# **CLEARFIELD CREEK WATERSHED TMDL Clearfield and Cambria Counties**

Pennsylvania Department of Environmental Protection

January 19, 2007

## **Comment and Response**

Figure 1. Impaired Waters in the Clearfield Creek Watershed

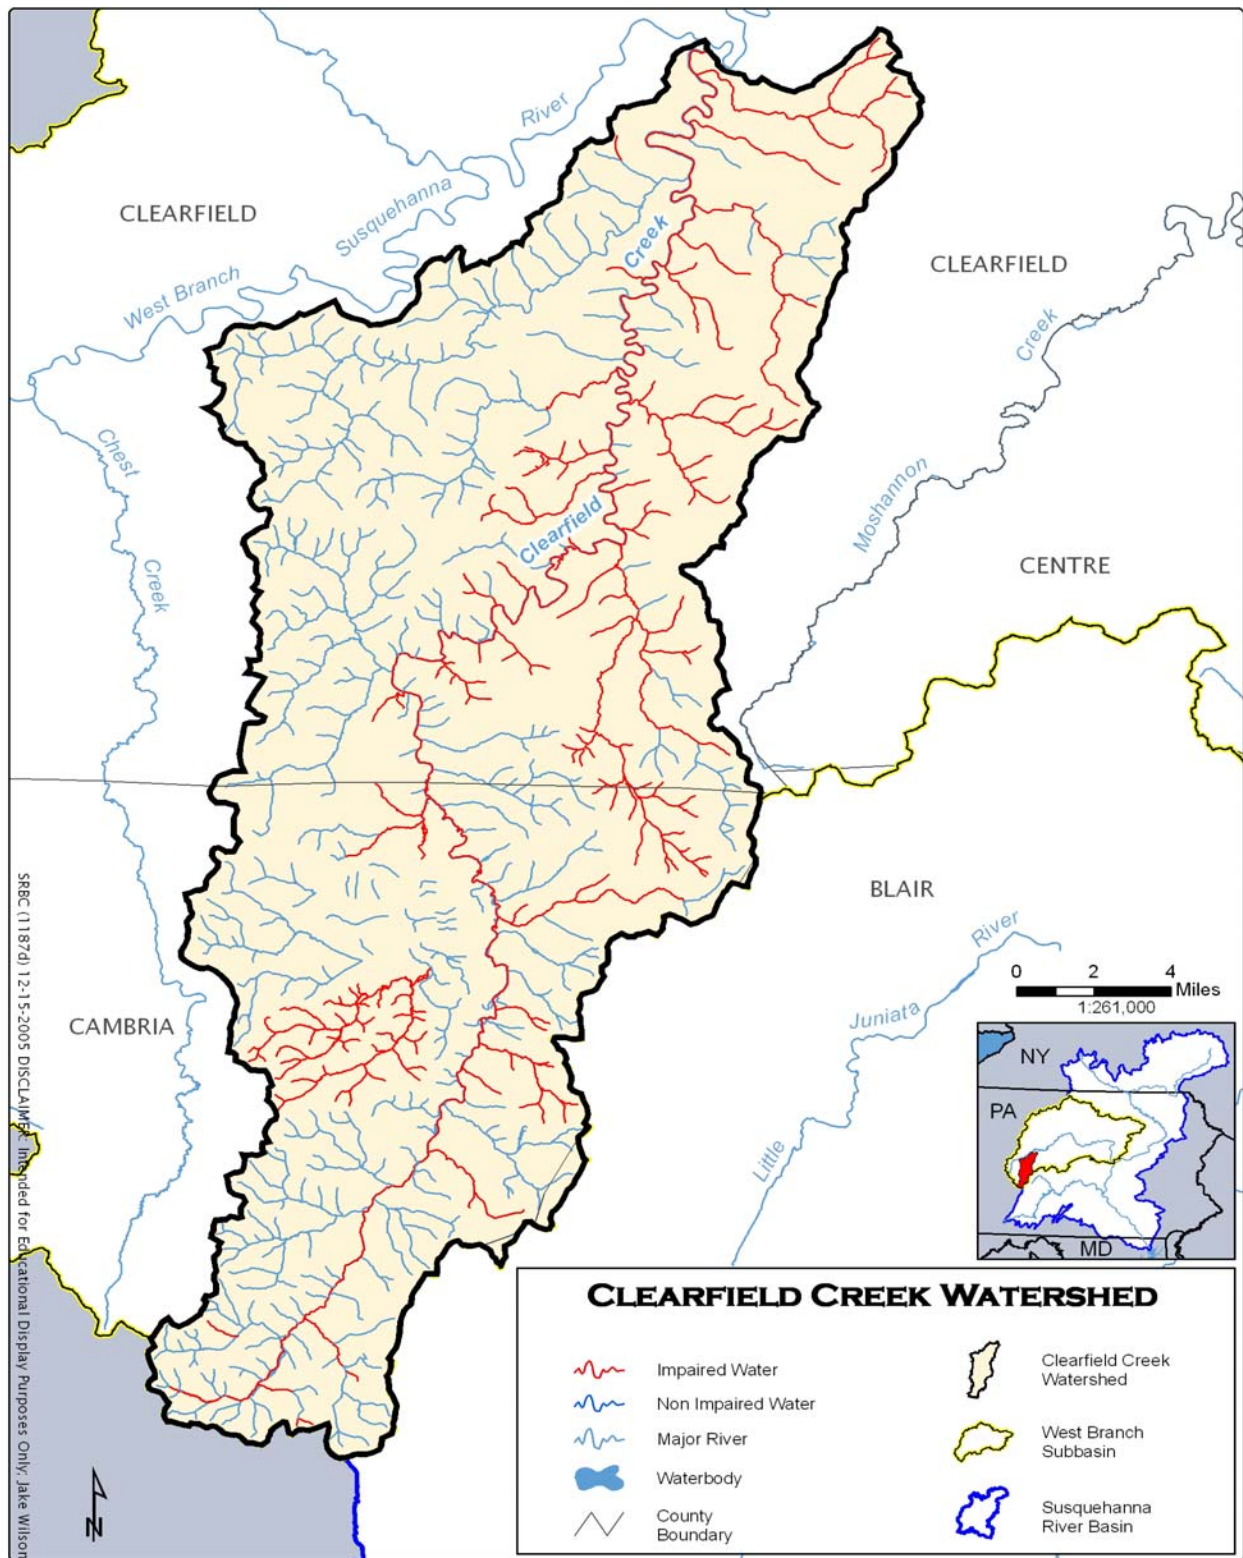
Figure 1, showing impaired waters. Blain Run near Coalport is badly degraded by AMD for about a mile. Also, a major Fe-rich discharge enters Turner Run about ½ mile above junction with Clearfield Creek. Bradley Run near Gallitzin is degraded. These sites are identified in the Clearfield Creek Assessment Report. This report is not mentioned in the previous section on past studies, though it is mentioned later. Also, the Scarlift reports on Clearfield Creek and Muddy Run are not mentioned.

According to the PADEP 2006 Integrated List of impaired waters, Blain Run, and Turner Run are not listed as being impaired. Bradley Run was added to the list of larger AMD tributaries to Clearfield Creek in the *Segments Addressed in this TMDL* section.

### CLEARFIELD CREEK WATERSHED - NORTHERN SECTION

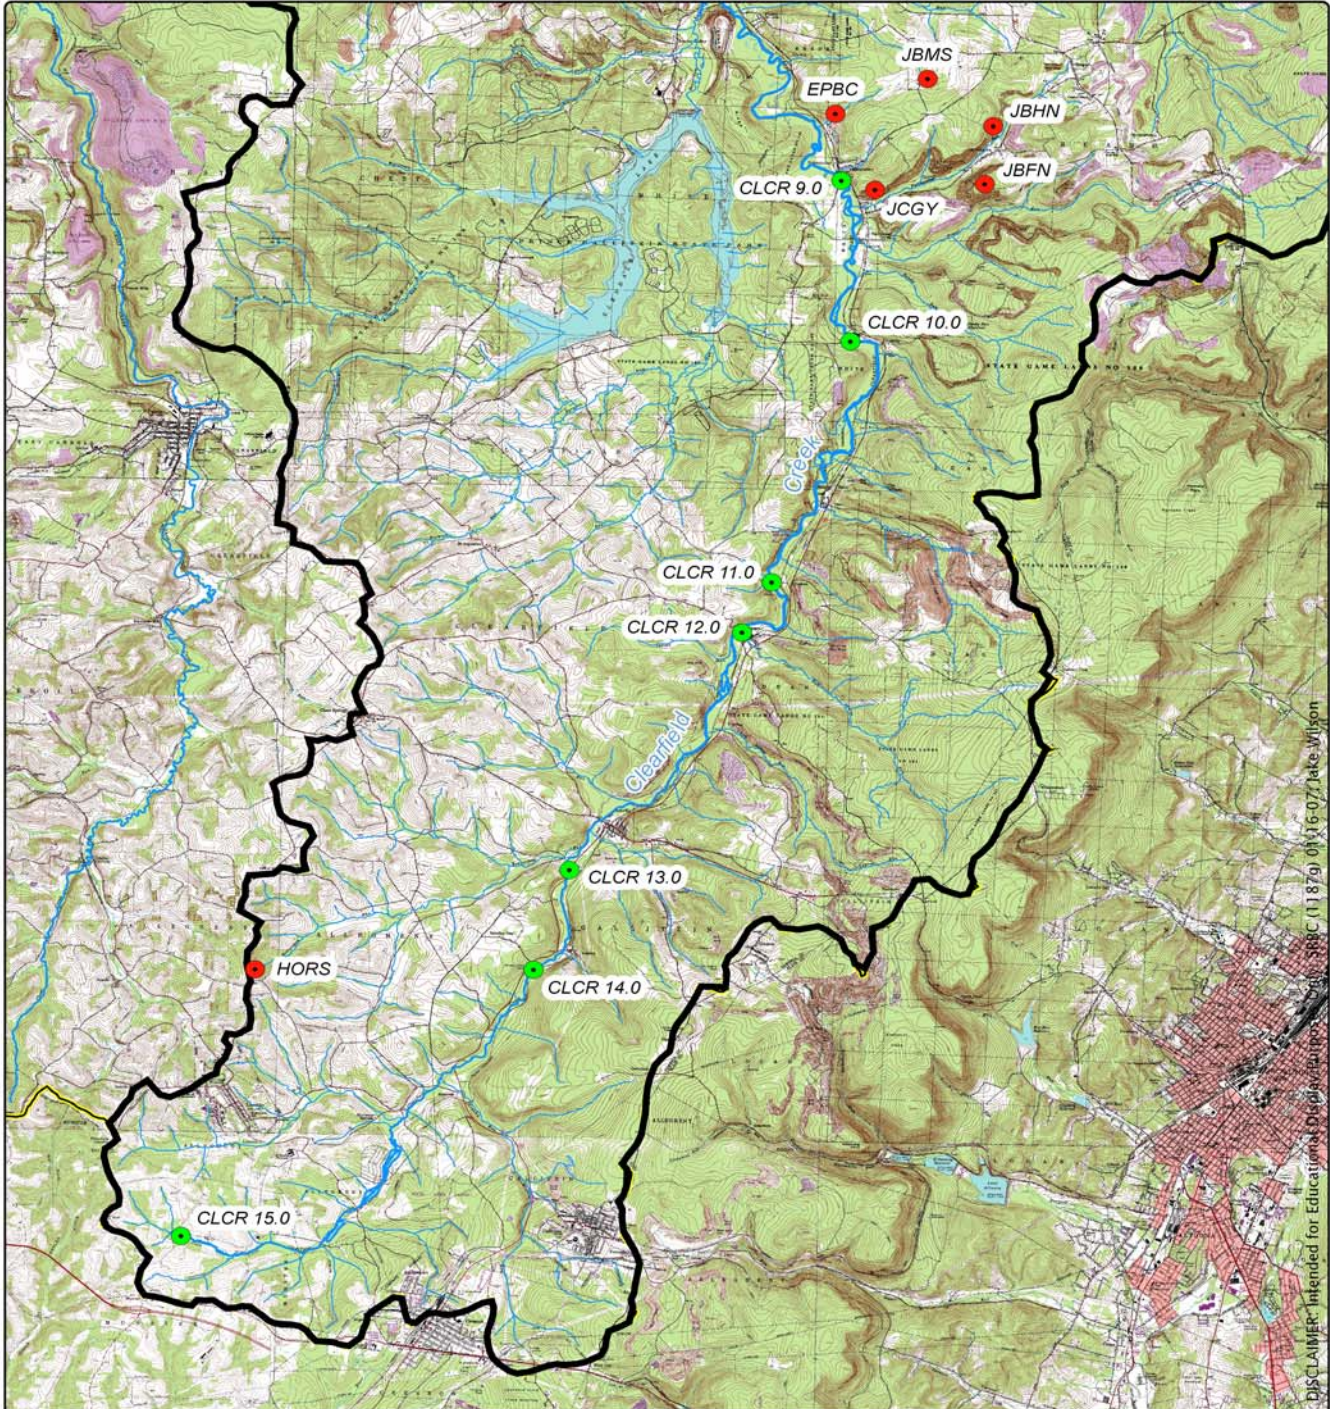
Map 1. The Cooney permit (11850102) near Buckhorn is not shown on the map, but has a Subchapter F point that is a significant source of acid. See my Restoration Plan for Little Laurel Run.
